Subject: Proposed development 6 Brighton St Balgowlah DA2021/1171

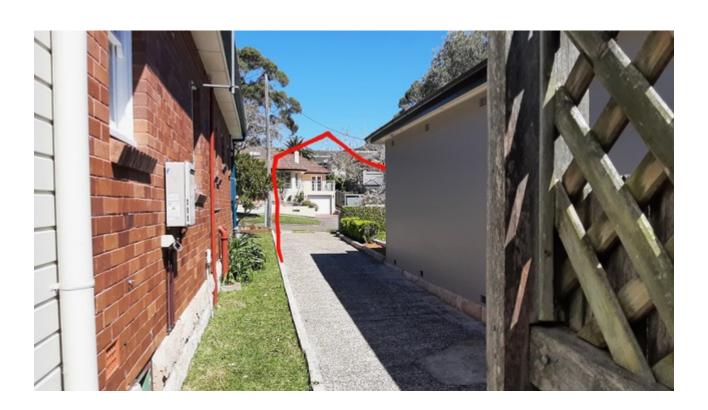
I would be happy for them to have the 'Storage Area' at the street end of their driveway with wall on boundary. Here it would have 8.5 m in length, ending on the southern side of the central bedroom window.

This is a better option as - it is away from the serious leaf buildup

-the bedroom window would not be shaded, as would be in current

design

-the guttering design would be more easily linked to the street

- no complicated recessed roof and gutter design above side door

inherent leaf build up and flooding problems.

- much less expensive

Red marker indicates suggested southern end of location storage area with benefits outlined above .

This section of their drive with proposed 1.8 m paling fence would be too narrow to be used for parking . Though there is still space beyond to the street .
